APPLICATION AND FINAL PLAT CHECKLISTDate January 25, 1991Name of Proposed Development LOT 1, BLOCK 1, CROSSINGS ADDITIONName of Developer RACETRAC PETROLEUM, INC.Address 300 Technology Ct., Smyrna, Georgia Phone 1-800-877-7357Owner of Record 30080
RACETRAC PETROLEUM, INC.Address 300 Technology Ct., Smyrna, Georgia Phone 1-800-877-7357Name of Land ~~Owner~~ / Surveyor / ~~Engineer~~ 30080
Don E. Gossett, R.P.L.S.Address 1015 Yvonne Dr., Joshua, Tx. 76058 Phone 817-295-0733Total Acreage 1.004Current Zoning "C"Number of Lots / ~~Units~~ OneSigned Don E. Gossett

FINAL PLAT LOT 1, BLOCK 1 CROSSINGS ADDITION

RACETRAC SITE PLAN - SH 205 NORTH OF IH-30 AND LAKESIDE CHEVROLET

Agenda Item: P&Z 91-1-CUP/SP/FP - Hold Public Hearing and Consider Recommending Approval of a Request From Racetrac, Inc., for a Conditional use Permit for a Building Not Meeting Materials Requirements and Approval of a Site Plan and Final Plat for a Self Serve Gas Station Located on SH-205 North of I-30

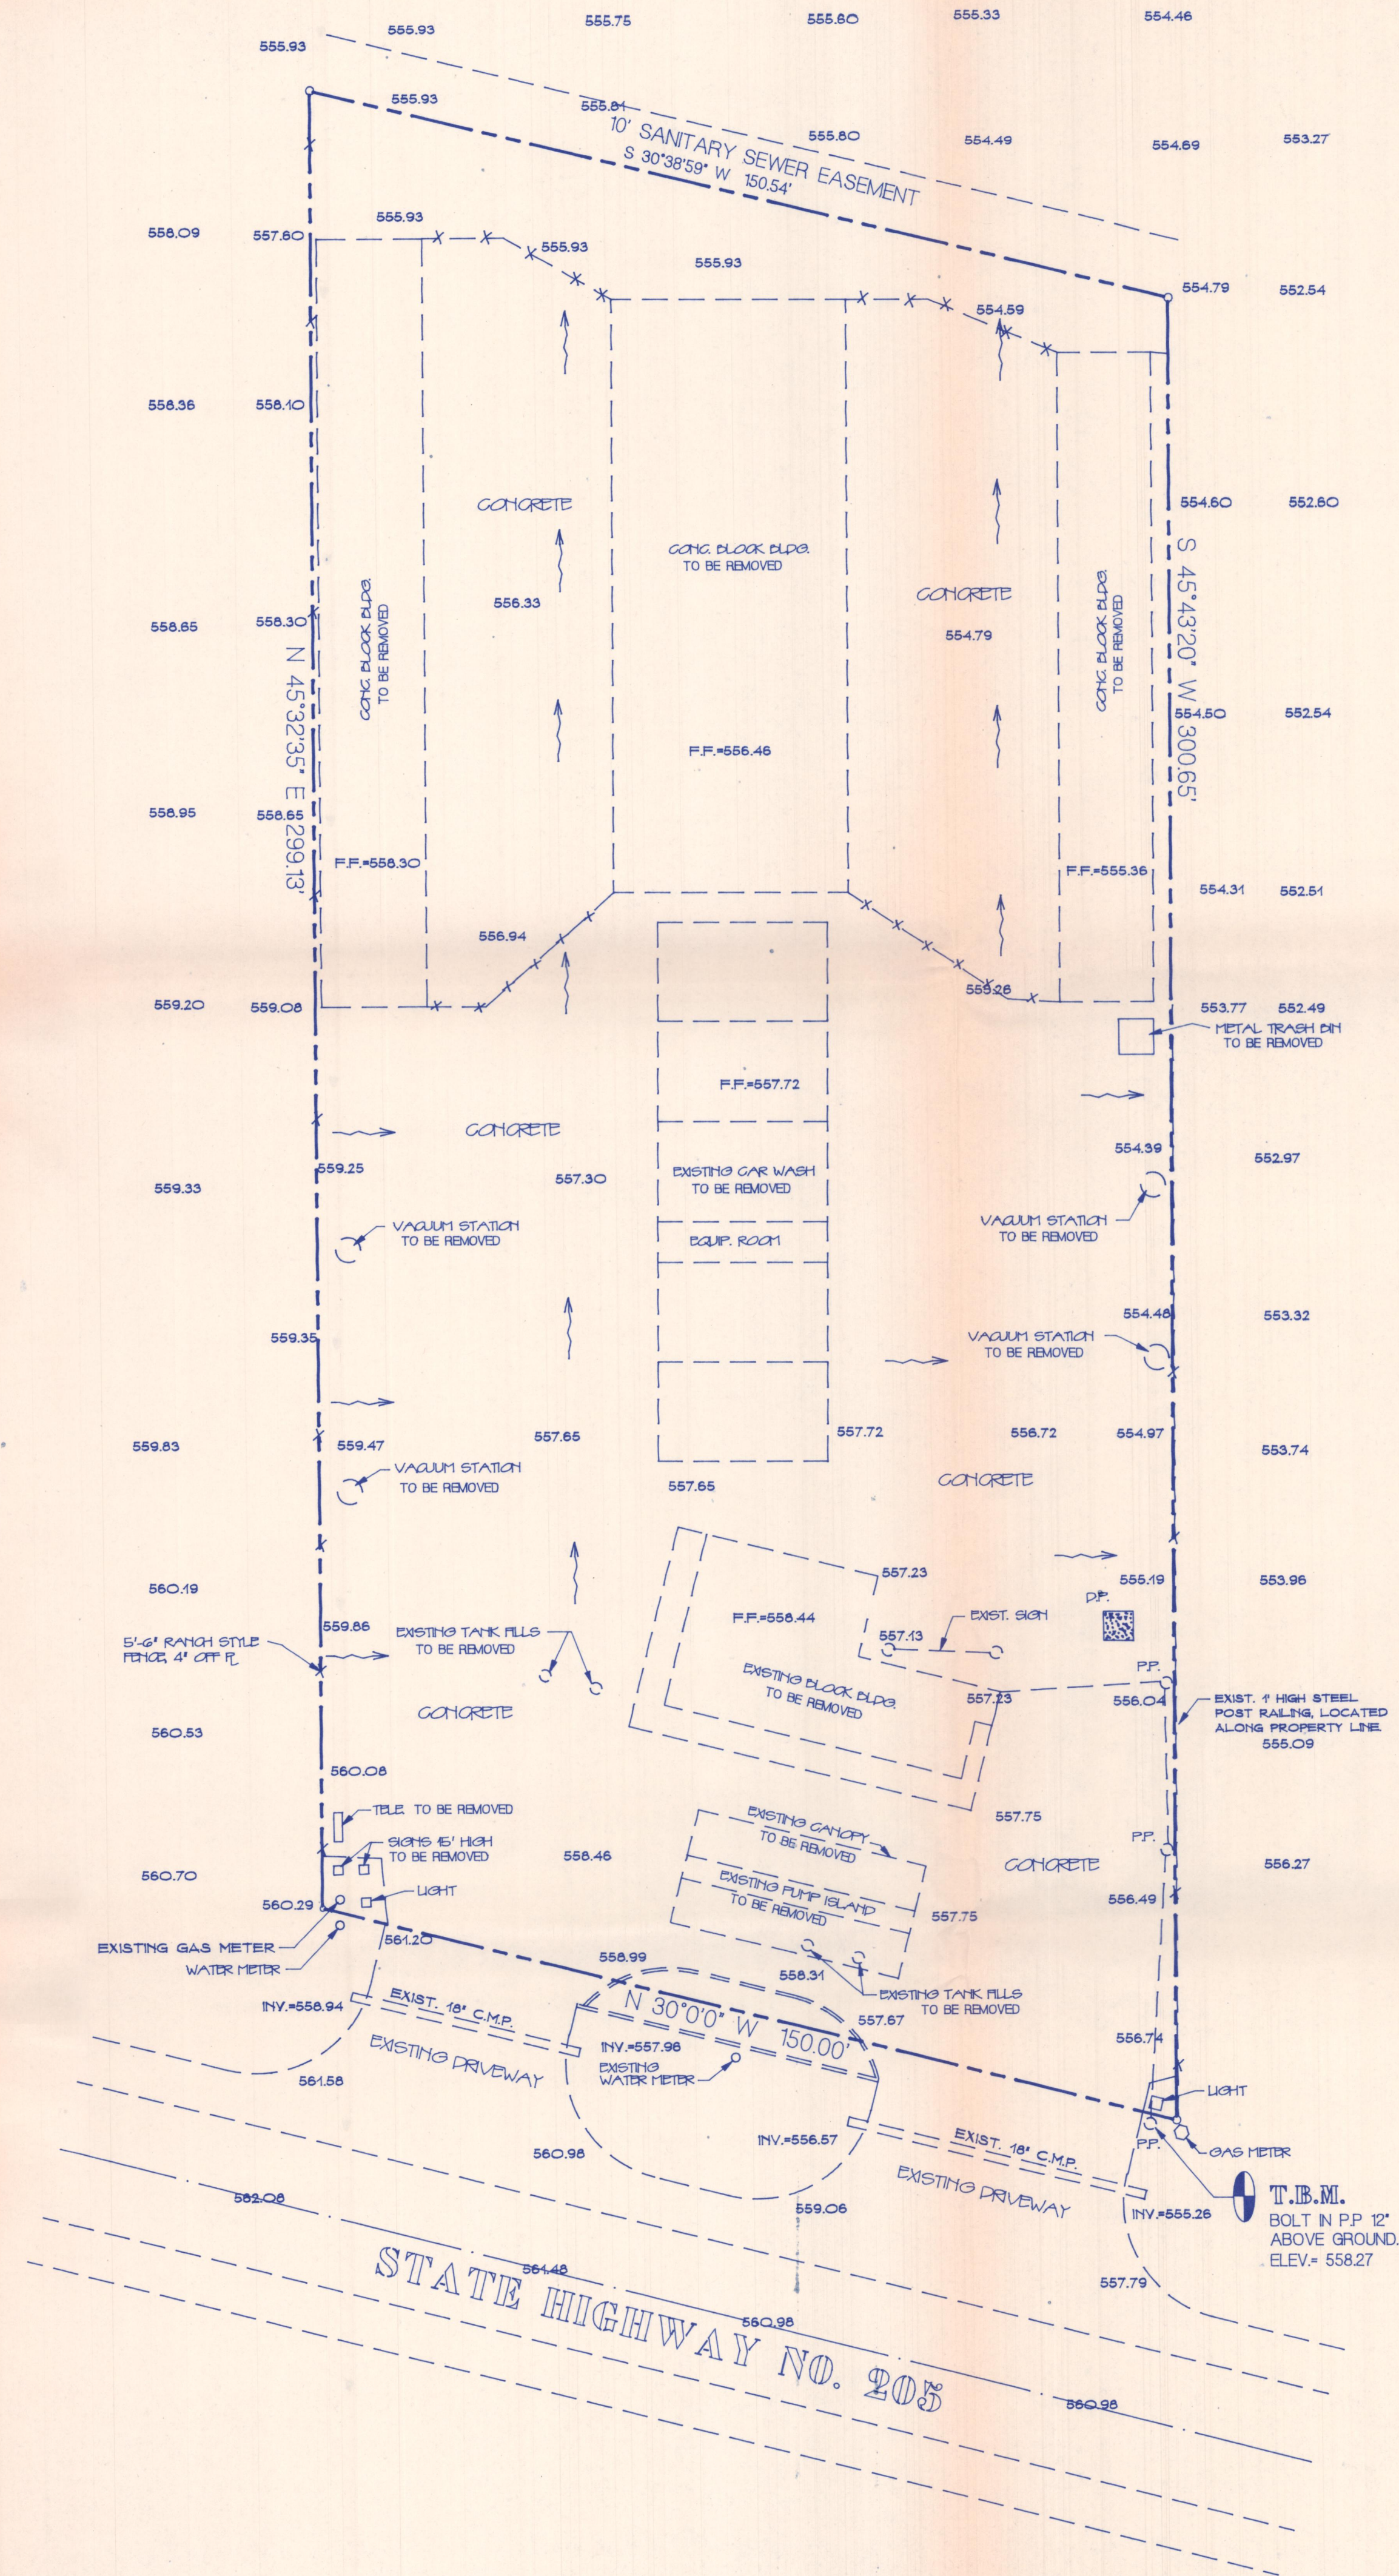
The property is not platted and they must complete that process in order to build. The plat meets our requirements with the exception of no faccess easment to the rear of the property and the inclusion of a utility easement along the frontage. They will provide this Thursday night.

The Commission recommended approval of the plat with the condition that a utility easement be dedicated along the front property line and that a 24 foot ingress and egress easement be provided along the south property line. They have added these items to the plat and a copy is attached.

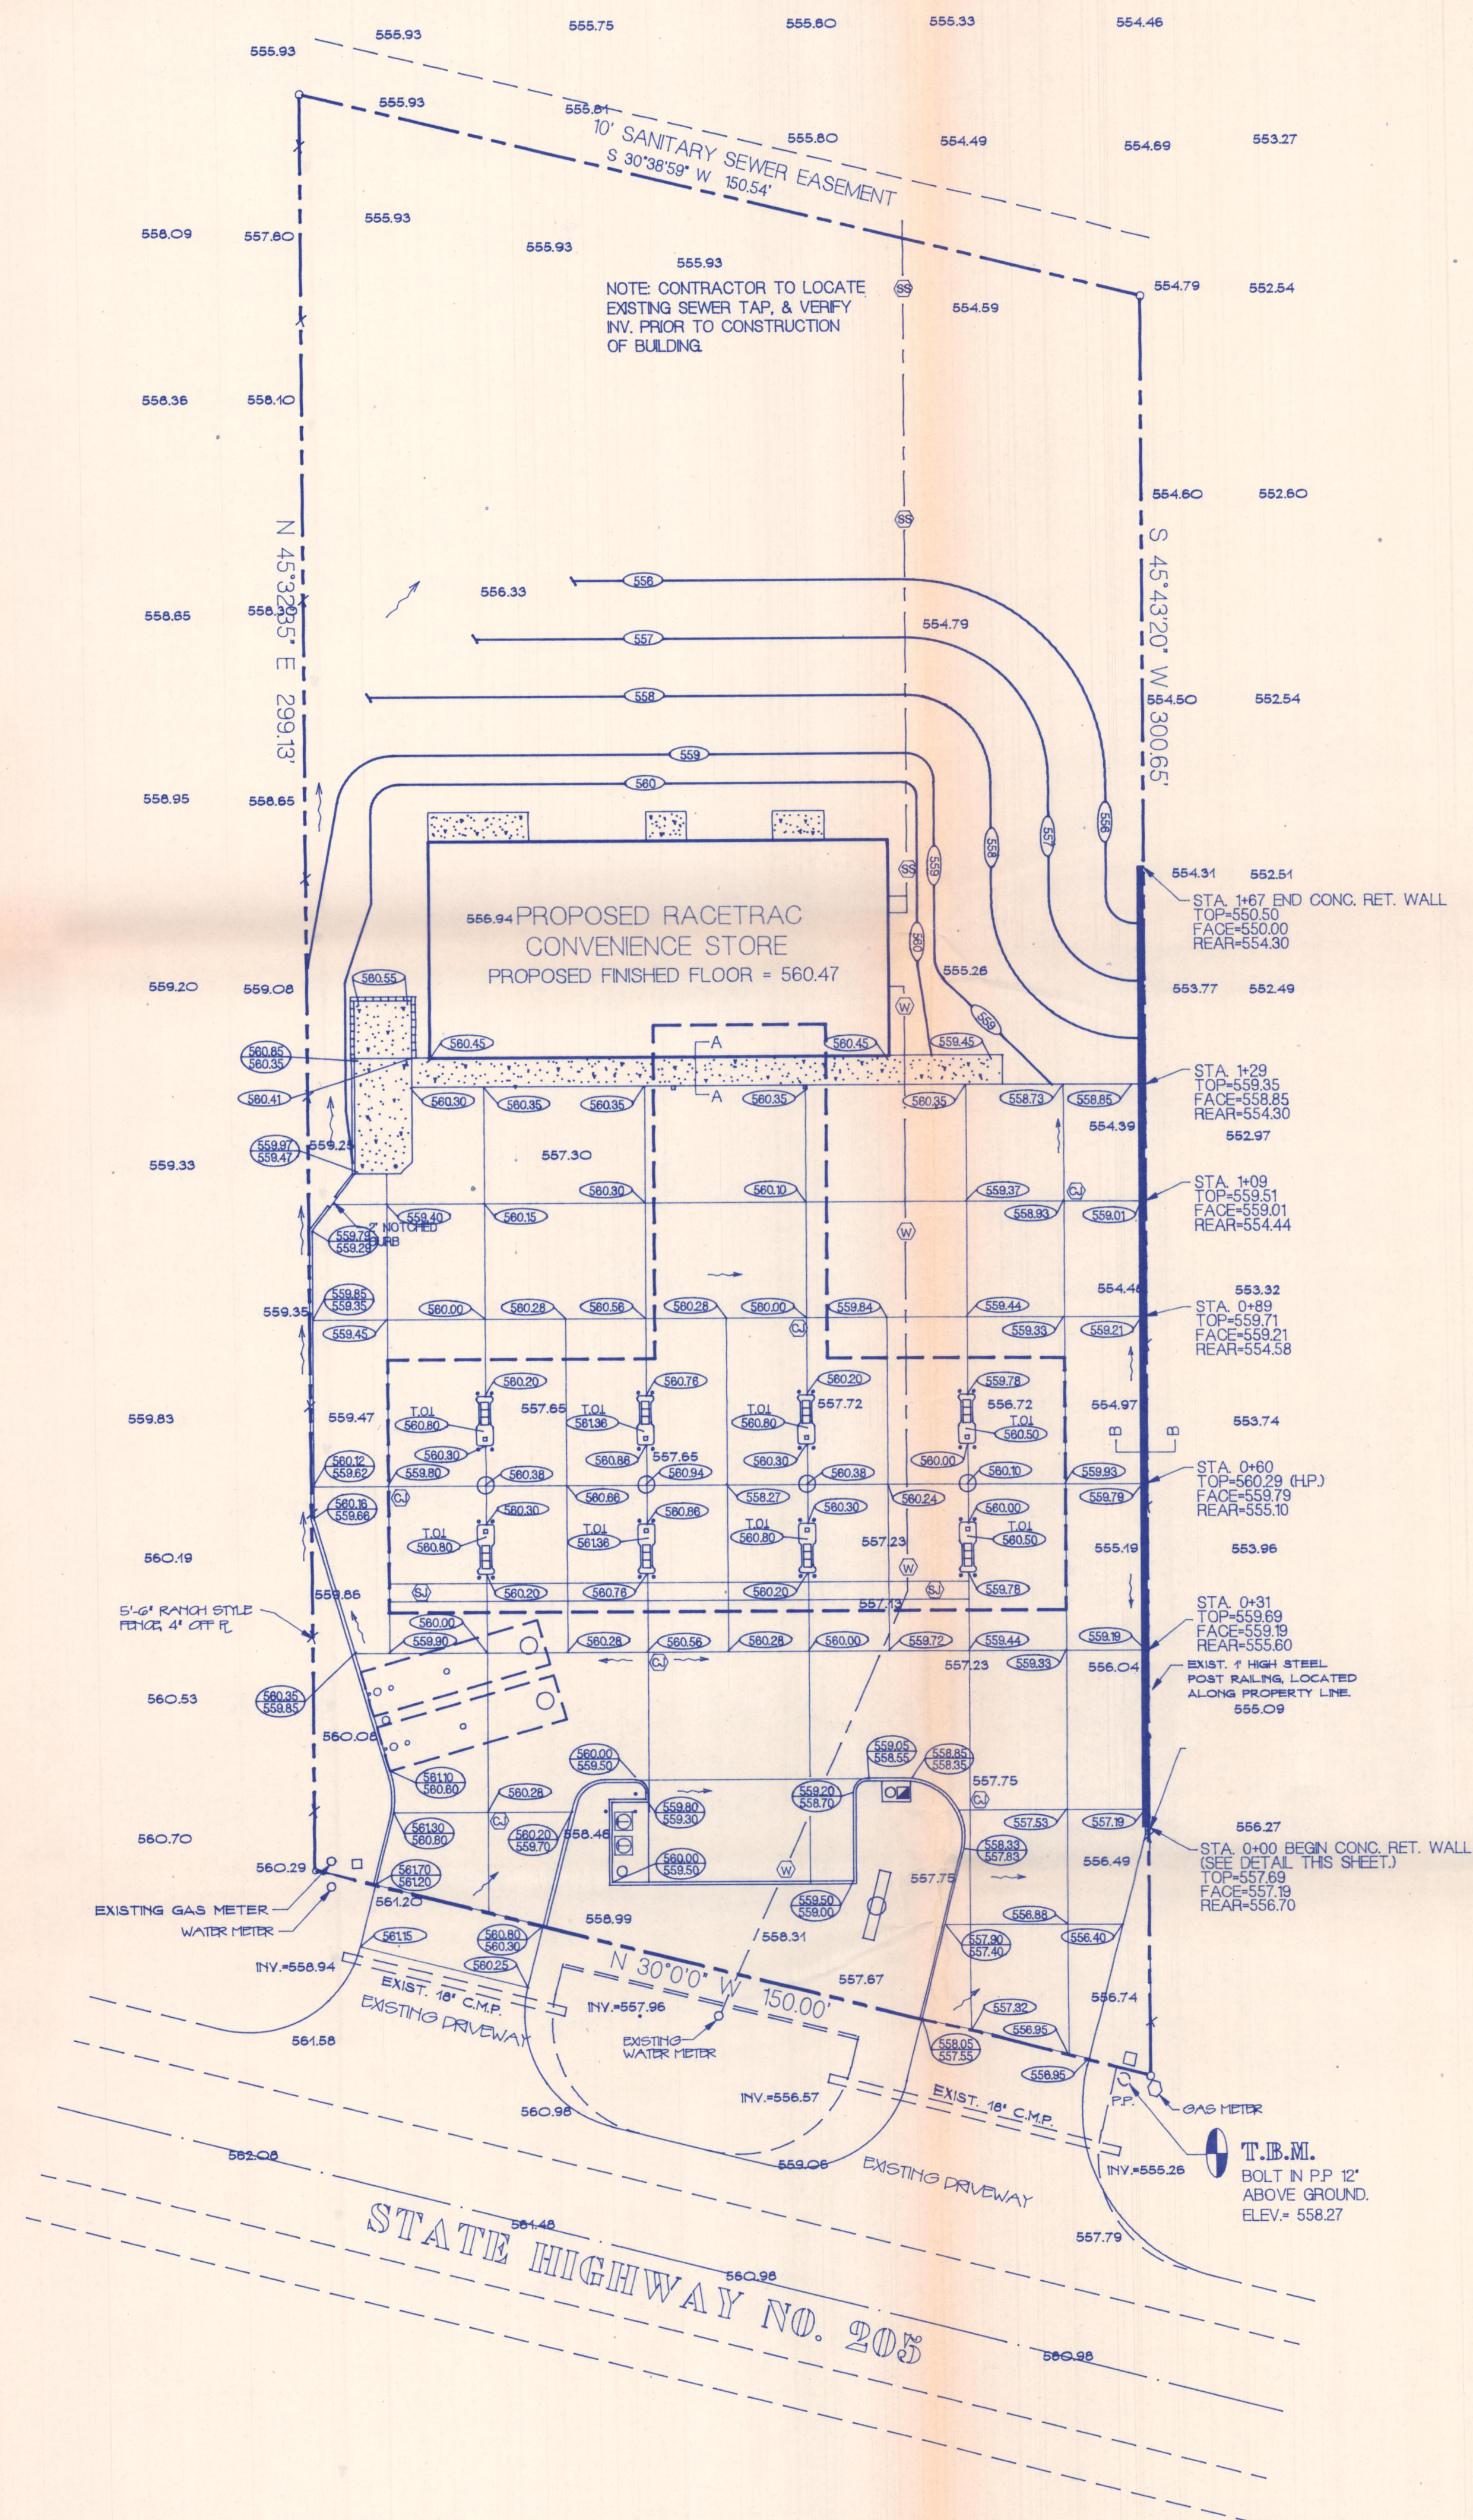
d. ^{row} area in front of the prop needs to be grassed -
show on plans.

13. Reduction of openings or reduce to one - need to show proximity of adjacent drives
14. Buddy square footage & dimensions?
15. 16 parking spaces - where are the 15 spaces
16. Elevation + color of signage + canopy
17. Nearest fire hydrant location
18. Possible ROW dedication

1. Overall, the site plan is well-conceived. Access to the pump islands, the underground tanks, and the convenience store parking is good.
2. There should be a designated access easement along the south side of the property to access the land east of this site.

3. The radii at each proposed driveway encroach upon the neighboring properties to the north and south. In order to correct this, three things could be done - reduce the driveway widths from 30 to around 24 FT, move the driveways inboard to the property thereby reducing the 68 FT clear space between driveways, and reduce the size of the radii. A small reduction of each of these factors would eliminate the encroachment problems without unduly sacrificing the site plan.

4. The site plan shown includes two driveways. City standards identify driveways for a site to be generally separated by distances of 150 FT. The plan shown, however, is a good one, and the site may have access in the future to a median opening at the north property line. The plan as presented seems best.

5. Some consideration should be given to setting up cross-access easement capability to the properties north and south of this site. While these adjoining properties may not want to take advantage of such easements at this time, there will come a time when SH 205 will have a raised median. It seems in the best interests of the City to require cross-access easements along major thoroughfares as a general means of helping to provide for future vehicular movement.

1. Require applicant to show joint access easement to the property east of this site.
2. Require applicant to show an access easement across the property, north-south, for the future potential use of the adjoining properties.
3. Eliminate the encroachment of the applicant's curb return radii onto adjoining properties.
